PLAN REVIEW SHEET

Petition #: RZP 2021-039

Address: 9327 Legranger Road

Request: RE-3 (O)

WAITING PAD ONLY WITH PLANTING STRIP STANDARD

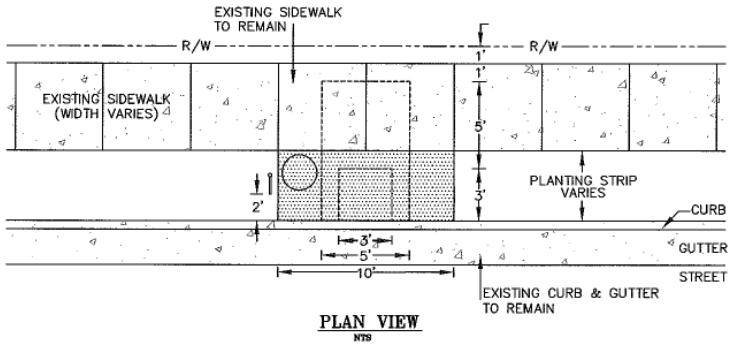
The site is located along a future CATS local bus route. CATS requests the construction of an ADA compliant bus pad per Land Development Standard 60.01B on Senator Royall Drive. The final location of the pads will be coordinated with the developer through the permitting process.
